DOH Review: Navy Groundwater Flow Models & Related Issues with the Navy CSM for the Red Hill Facility

*The Department of Health Hawaii (DOH)
Technical subject matter experts
Robert Whittier, Don Thomas, G.D. Beckett
& Anay Shende*

October 19, 2021

Navy 3D Lithologic Model – Barrel Logs

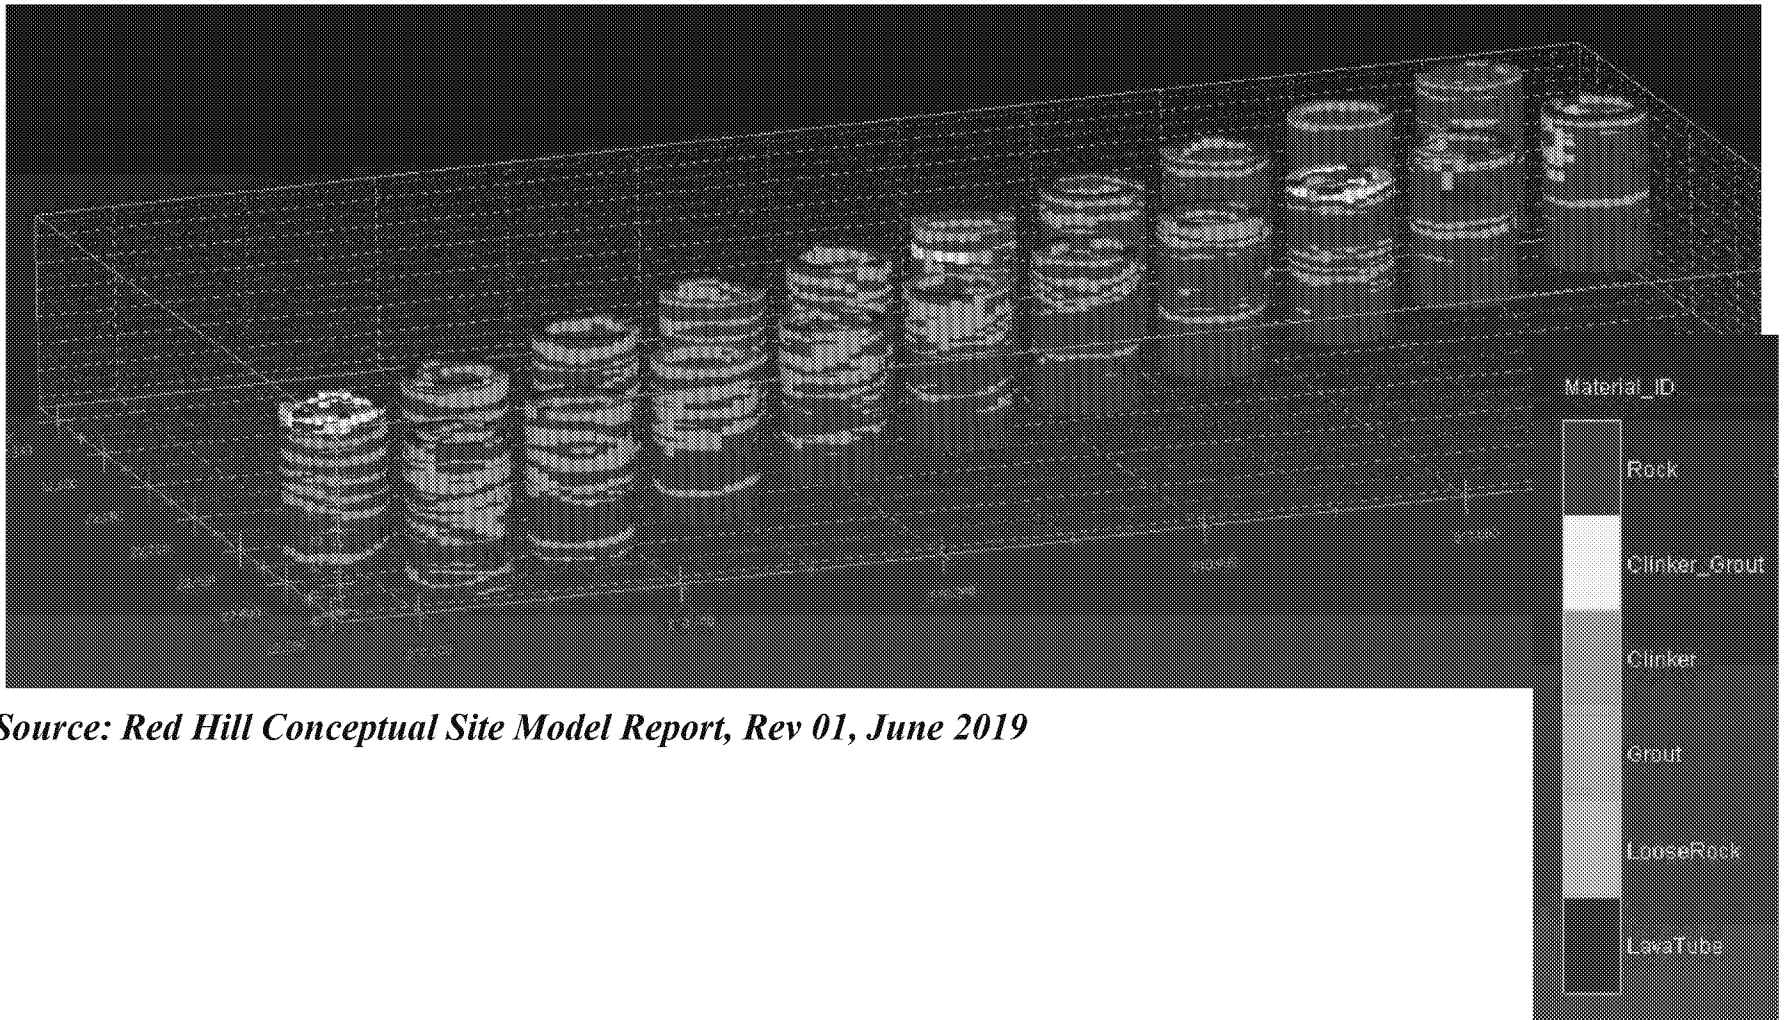
(same issue, Dr. Tonkin will address)

Lab vs. Field Scale – Permeability

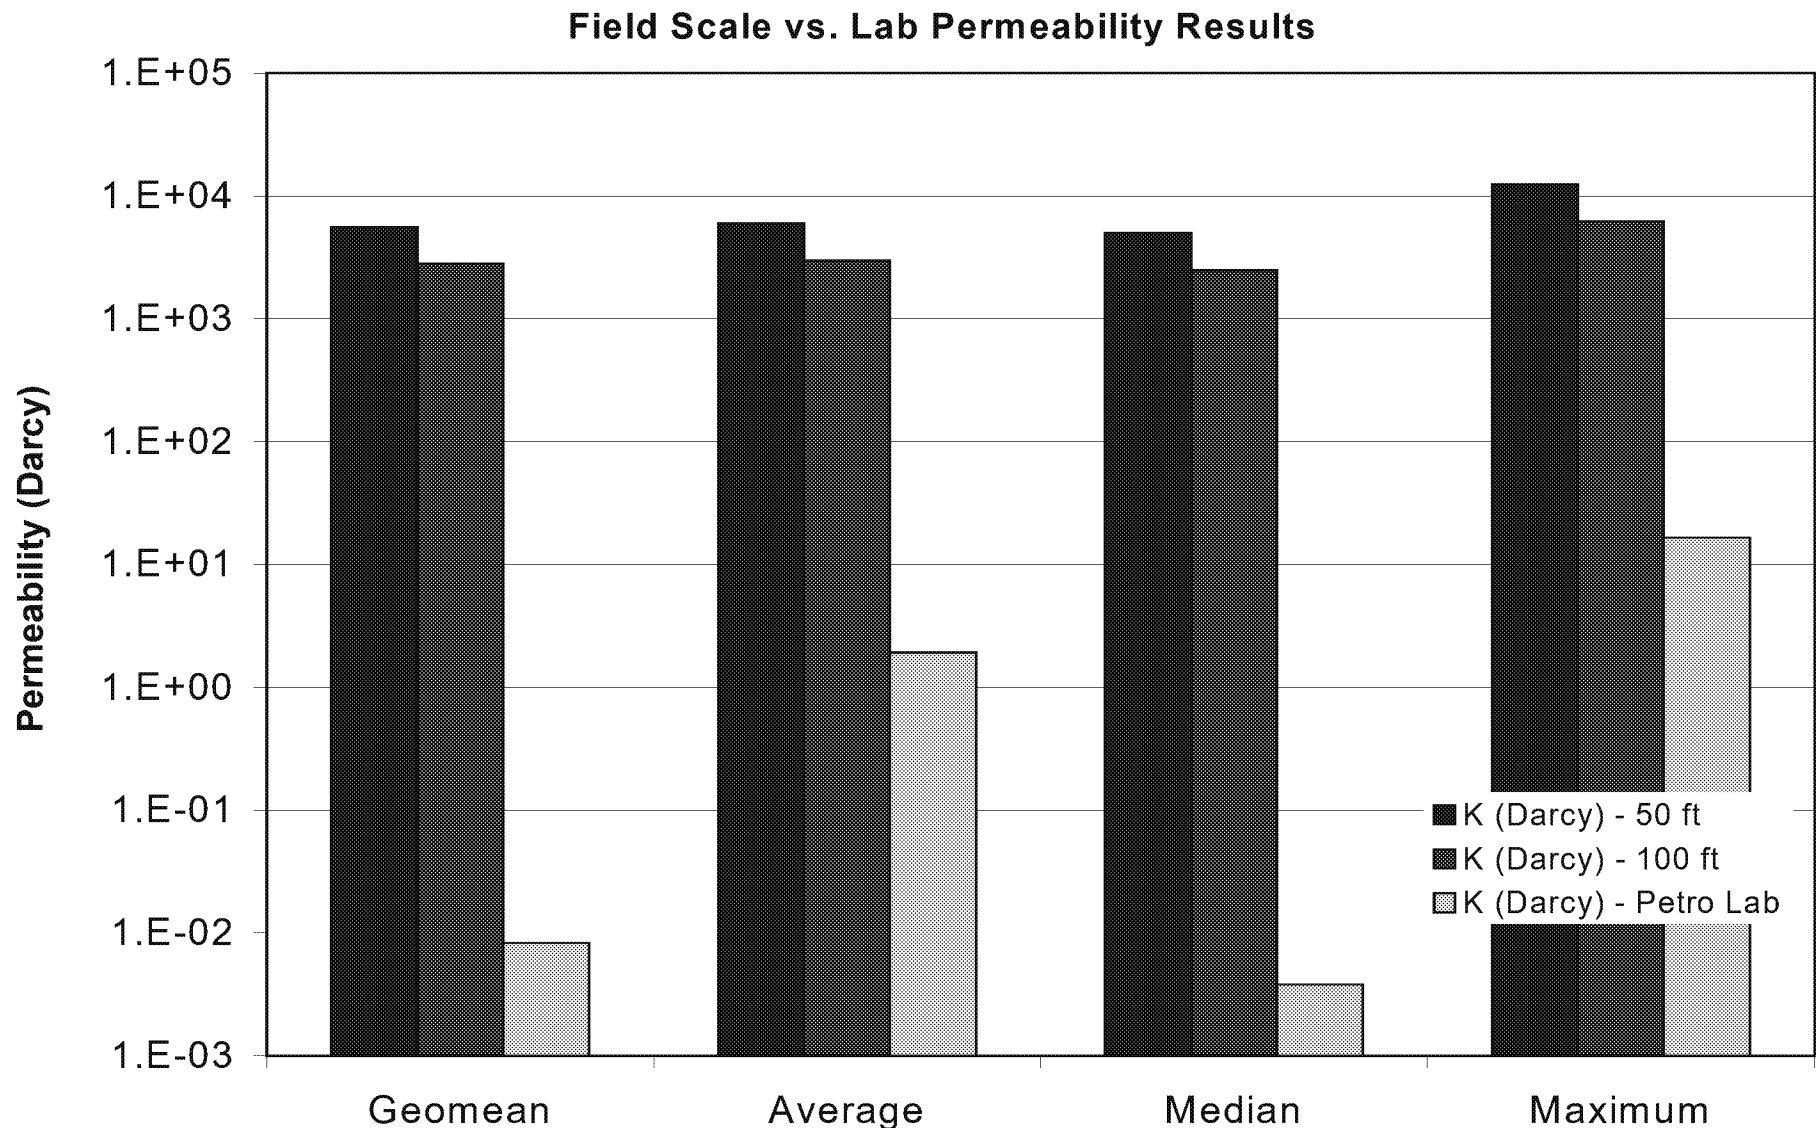
(Site lab data are not comparable to field scale)
